Albury to Illabo Preferred Infrastructure Report

**INLAND
RAIL**

This Preferred Infrastructure Report has been prepared for the Albury to Illabo (A2I) section of the Inland Rail program (the proposal). The Preferred Infrastructure Report addresses the direction made by the Planning Secretary in accordance with section 5.17(6)(b) of the *Environmental Planning and Assessment Act 1979* (EP&A Act) and describes and assesses the proposed amendments.

Figure 3-11 Revised Construction layout of Wagga Wagga Station and surrounds

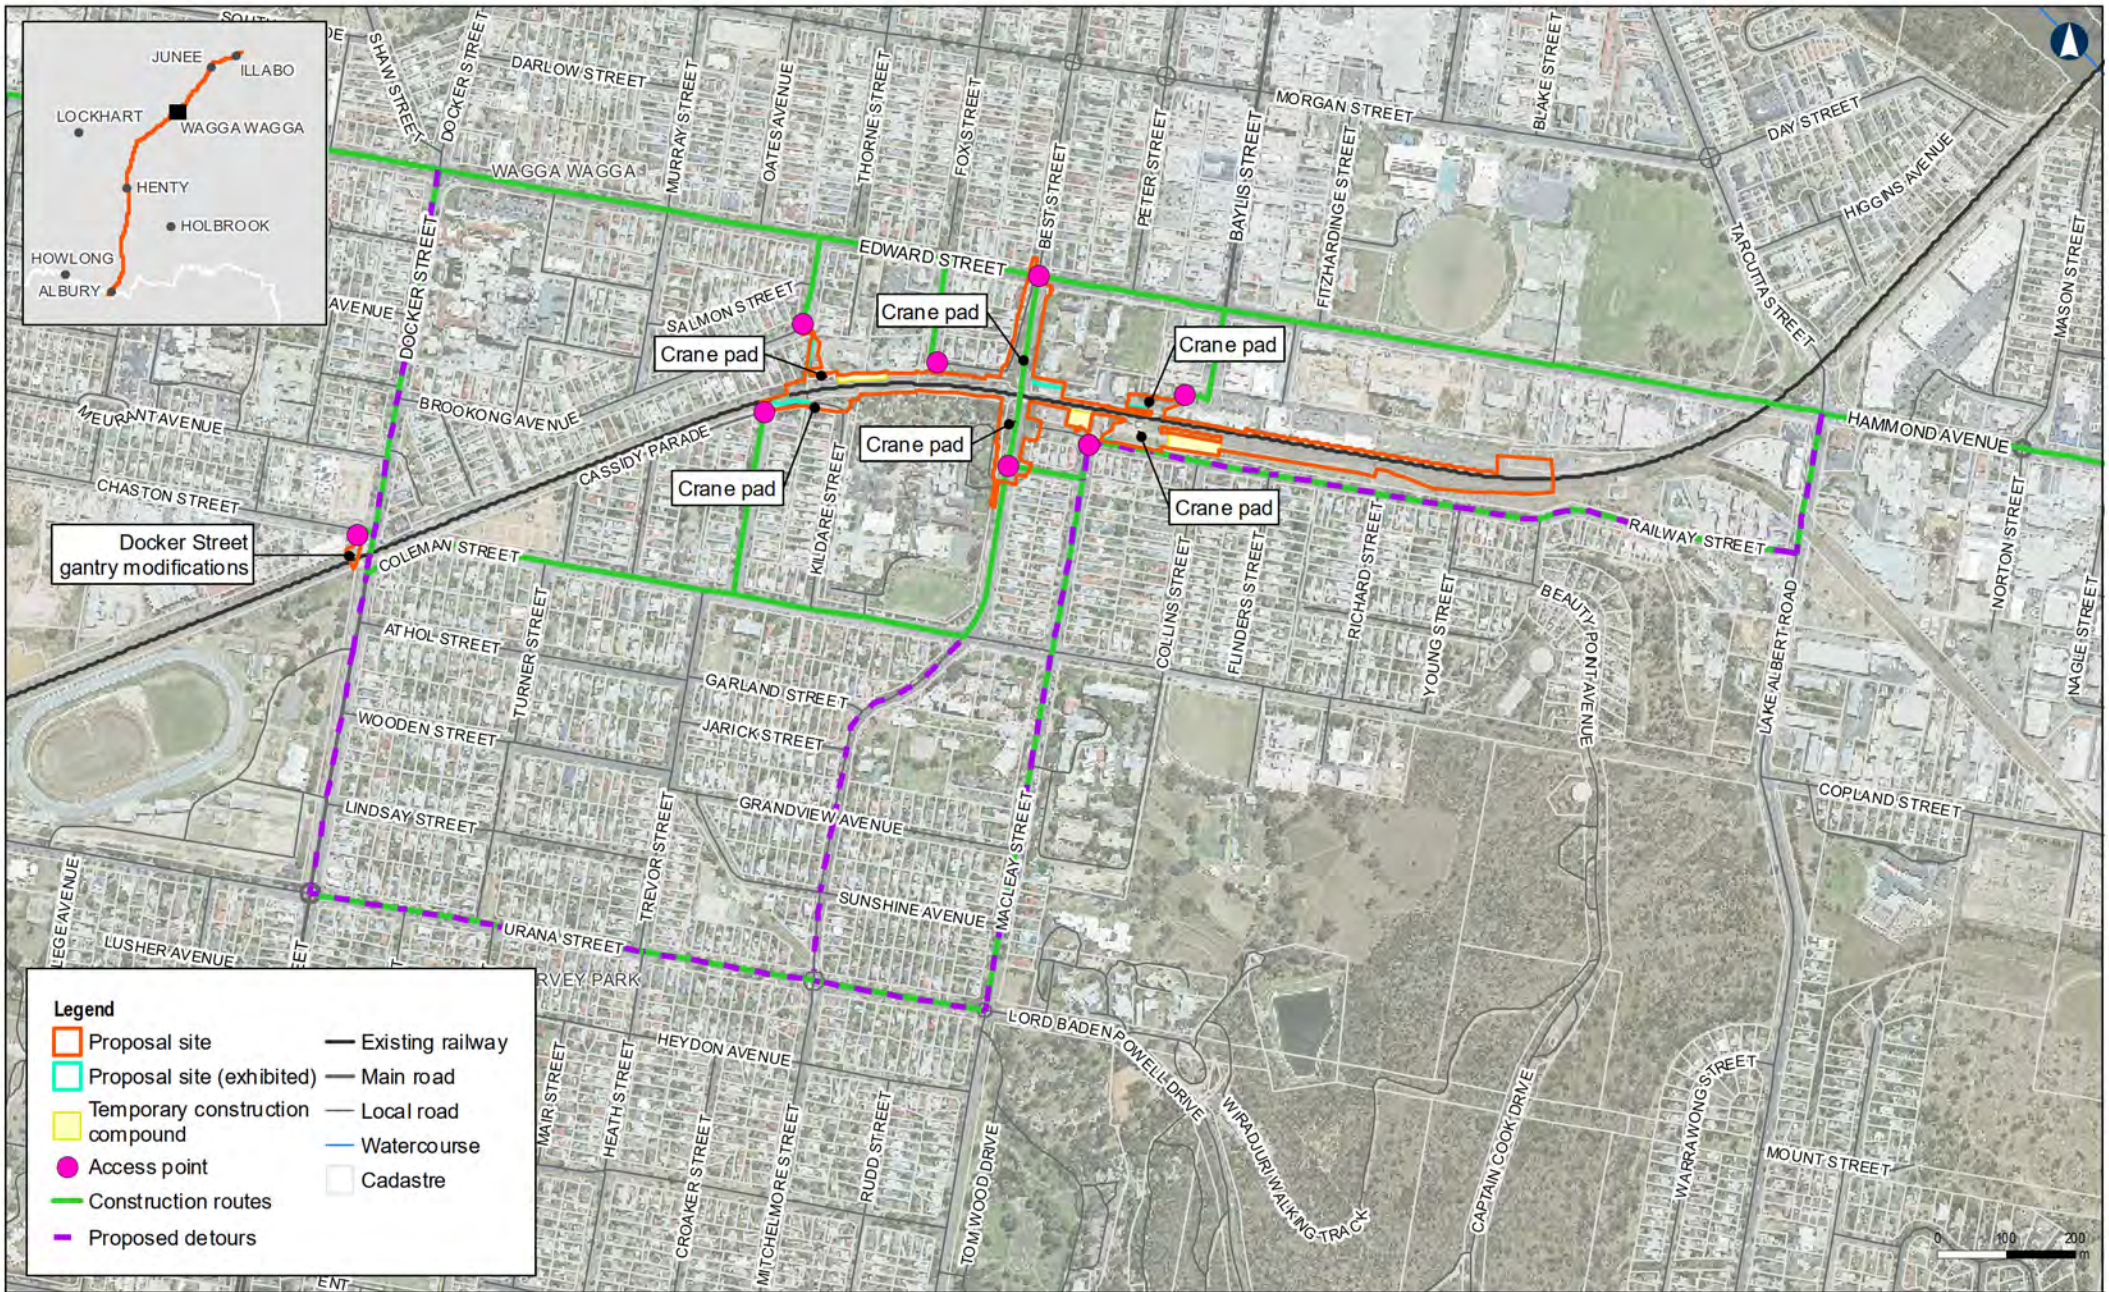
Edmondson Street bridge (refer to Figure 3-11)	The proposal site has been extended by about 10 m on the north-eastern side of Edmondson Street bridge to accommodate the new pedestrian bridge (refer to section 3.2.1.1). The proposal site now meets the southern boundary of South Wagga Public School. No change to site access points is proposed.
	Wagga Wagga Station pedestrian bridge Wagga Wagga Yard clearances (refer to Figure 3-11)	Th proposal site has been extended in two locations to facilitate construction. It has been extended within the car park of Multicultural Council of Wagga Wagga Centre to the north of the rail corridor and a small increase to the south of the rail corridor has been included to bring the proposal site to the edge of the Railway Street road. No change to site access points is proposed.
Junee	Harefield Yard clearances (refer to Figure 3-12)	The proposal site has been refined to remove the access through the intermodal as it is no longer required for construction. No change to site access points is proposed.

Figure 3-13 Revised Construction layout of Junee Station and surrounds

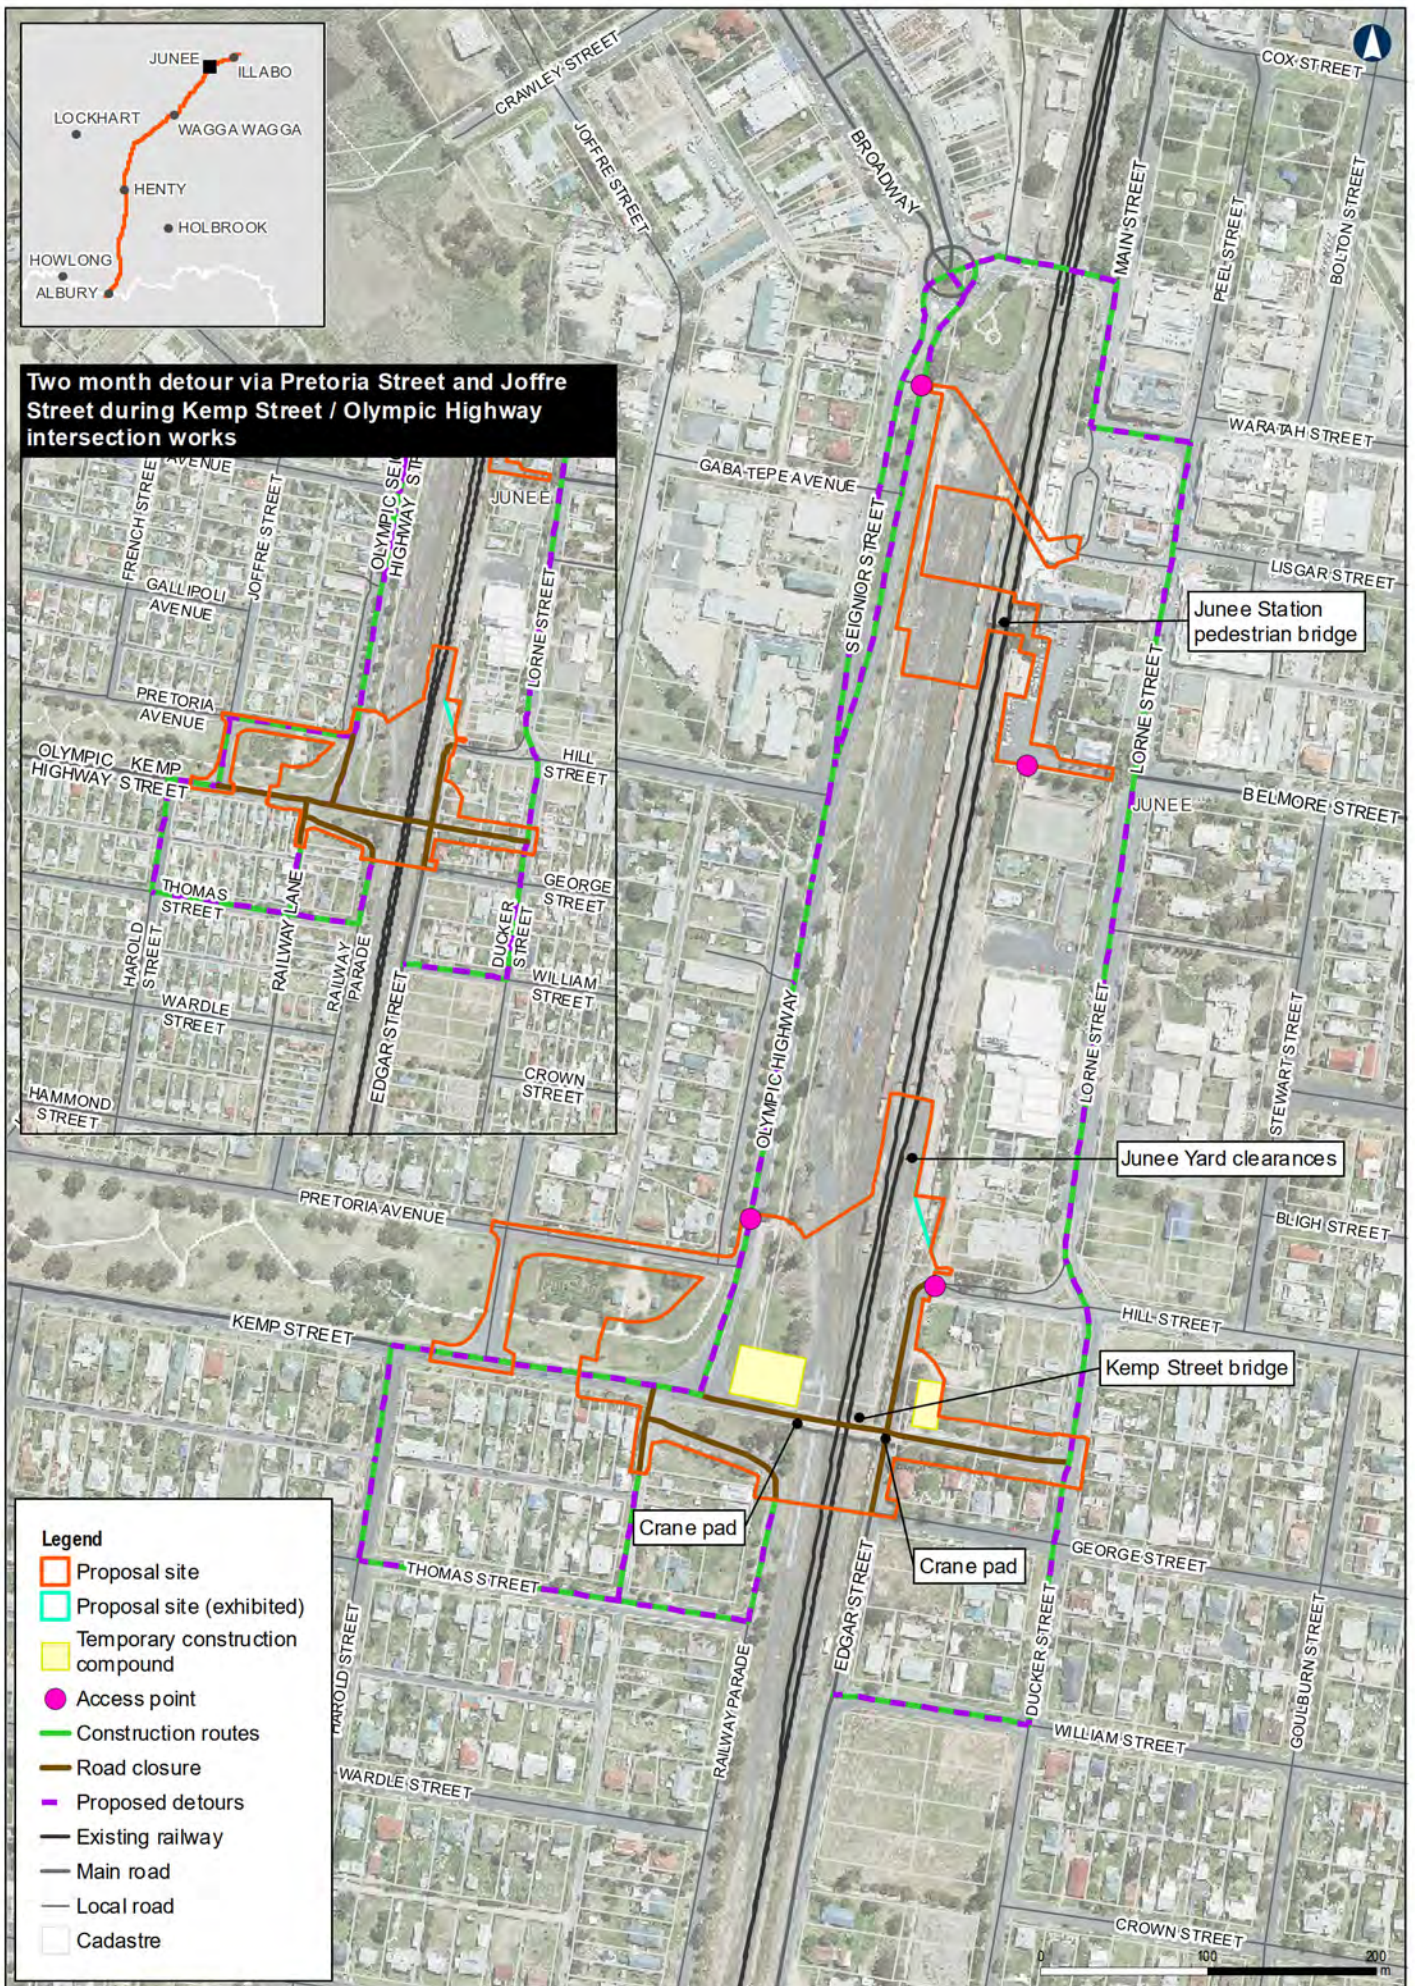
Kemp Street bridge Junee Yard clearances (refer to Figure 3-13)	The proposal site has been extended along the rail corridor on the north eastern side of Kemp Street bridge to accommodate the new pedestrian bridge (refer to section 3.2.1.1). A small 10 m extension into the Hill Street road reserve has also been included to tie-in with the footpath network. No change to site access points are proposed.
	Junee to Illabo clearances (refer to Figure 3-14)	The proposal site has widened to accommodate the proposed changes to LX605 (refer to section 3.2.1.4). This includes an additional permanent land requirement of a section of Crown land. No change to site access points are proposed.

Figure 6-3 Pedestrian detours and staging at Wagga Wagga Station and surrounds

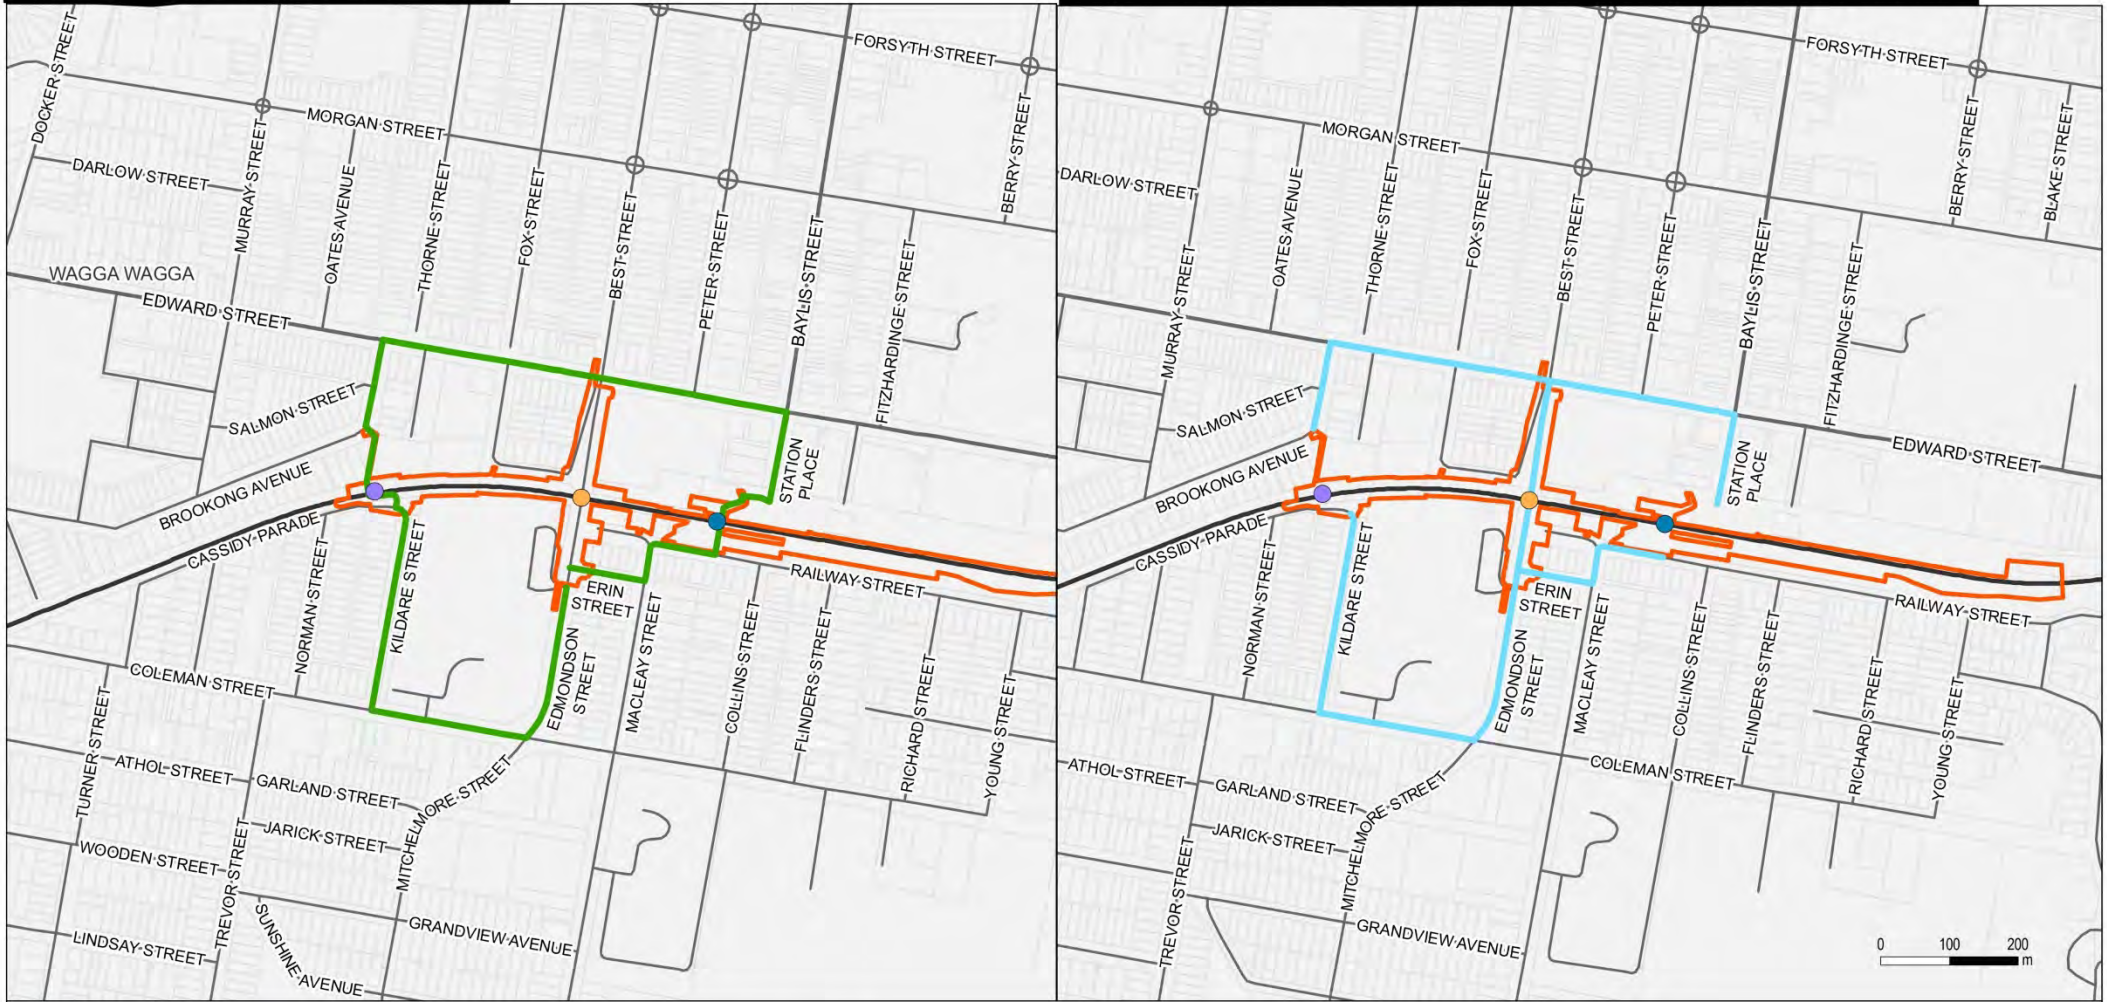
As described in section 3.2.2.2, the proposed staging of the closure of the bridges in Wagga Wagga has been revised since exhibition of the EIS. Bridge construction sequencing would commence with Edmondson Street, followed by the Cassidy Parade and Wagga Wagga Station pedestrian bridges (see Figure 6-3). Construction planning and delivery would apply best endeavours to ensure closure of the Cassidy Parade and Wagga Wagga Station pedestrian bridges would commence following the availability of pedestrian movement across either the Edmondson Street road or pedestrian bridge; however, as construction timing is driven in part by rail possessions, there may be a short period of time where Edmondson Street bridge is closed at the same time as one of the other two bridges.

Stage 1 - Edmondson Street bridge closed

Stage 2 - Cassidy Parade and Wagga Wagga Station pedestrian bridges closed
